**SAN ANTONIO WATER SYSTEM**  
**WATER PRODUCTION FACILITIES DISINFECTION SYSTEM UPGRADES PROJECT**  
**SAWS Job No. 12-6004**  
**SAWS Solicitation No. B-14-042-DD**

**ADDENDUM NO. 2**  
**August 7, 2014**

SHEET **M-04**  
30 OF 125

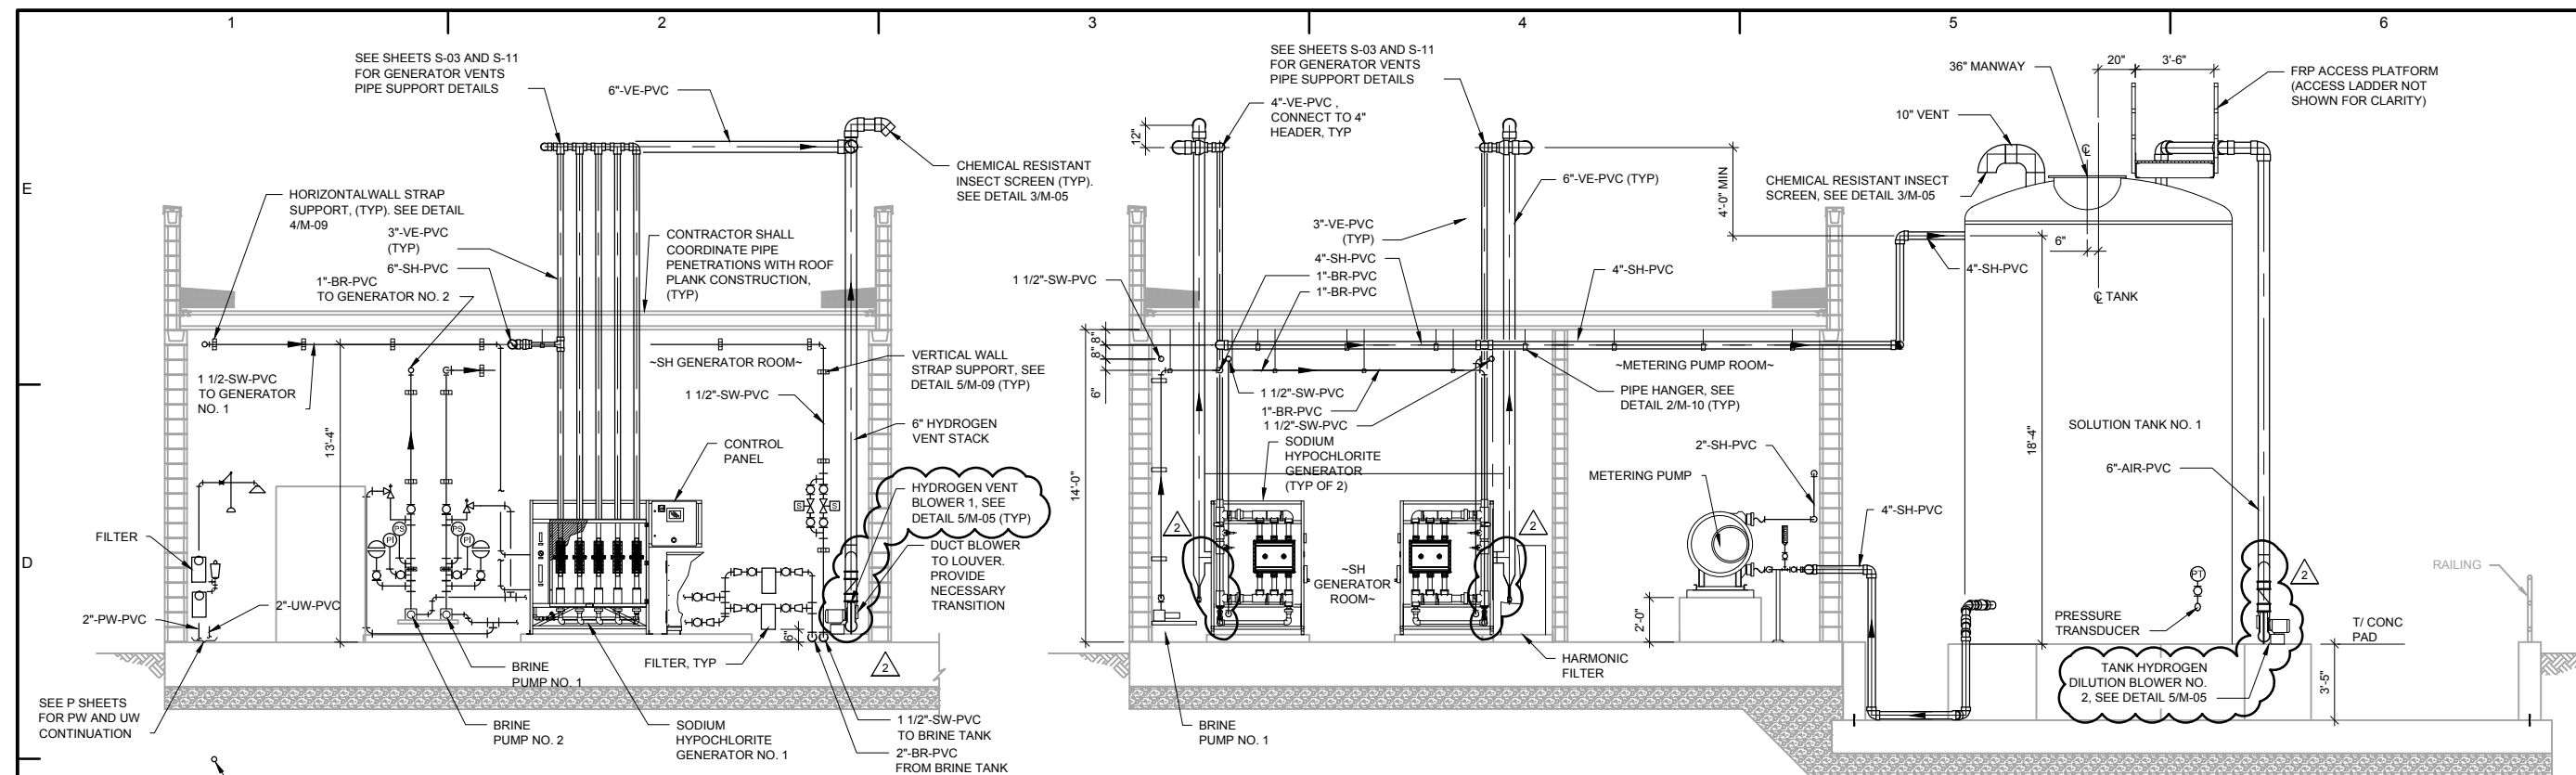
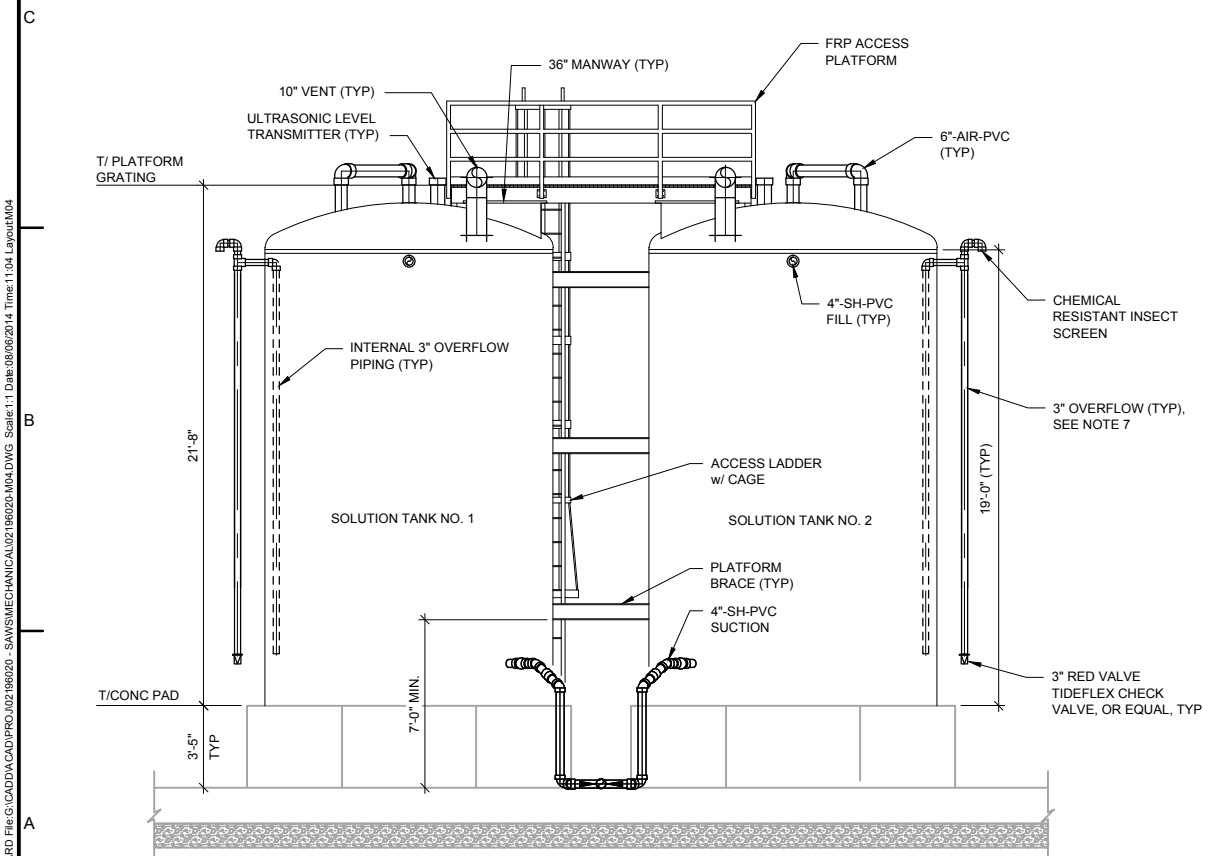
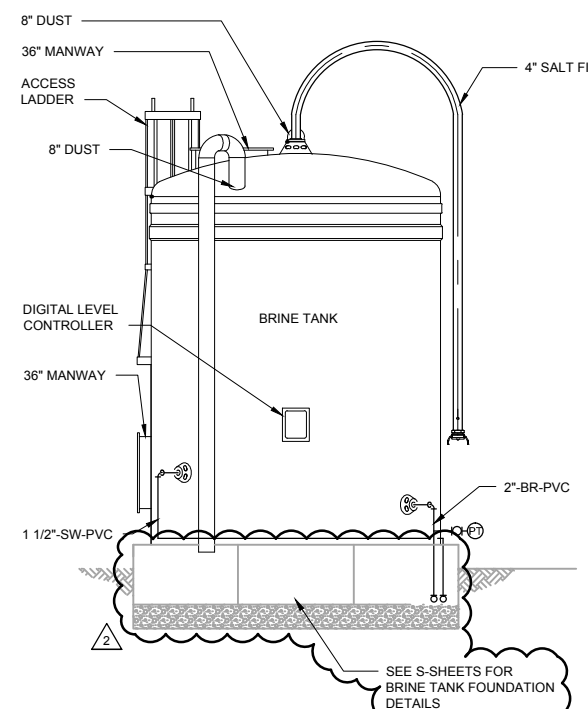
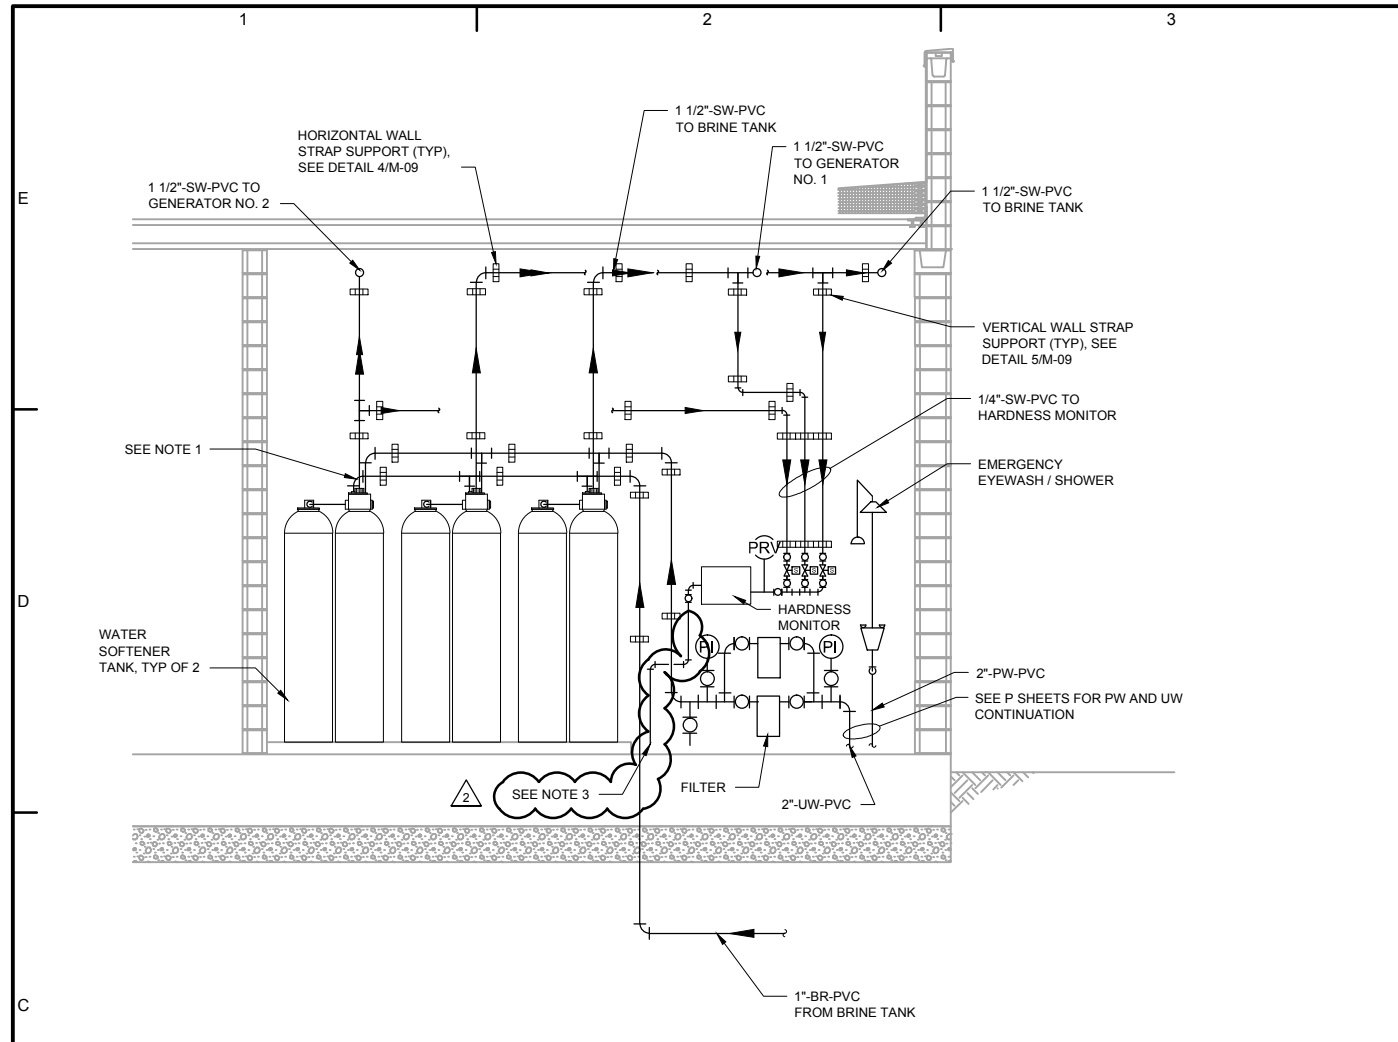
**11. Sheets M-03 and M-04**

- a. Brine tank foundation callouts have been updated to match Structural sheets
- b. Update blower layout

**HYDROGEN VENT BLOWER**  
**5 DETAIL**  
M-05 NOT TO SCALE

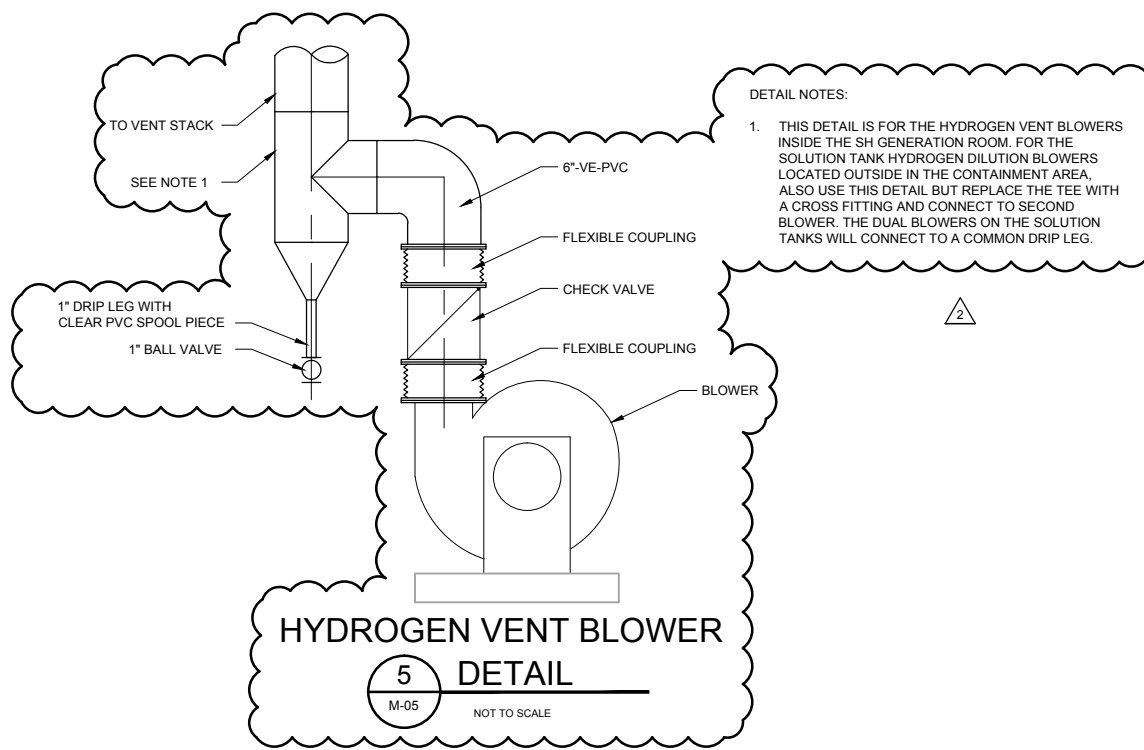
**12. Sheet M-05**

- a. Add blower drip leg callout and detail
- b. Add Note 3

- DETAIL NOTES:
- THIS DETAIL IS FOR THE HYDROGEN VENT BLOWERS INSIDE THE SH GENERATION ROOM. FOR THE SOLUTION TANK HYDROGEN DILUTION BLOWERS LOCATED OUTSIDE IN THE CONTAINMENT AREA, ALSO USE THIS DETAIL BUT REPLACE THE TEE WITH A CROSS FITTING AND CONNECT TO SECOND BLOWER. THE DUAL BLOWERS ON THE SOLUTION TANKS WILL CONNECT TO A COMMON DRIP LEG.
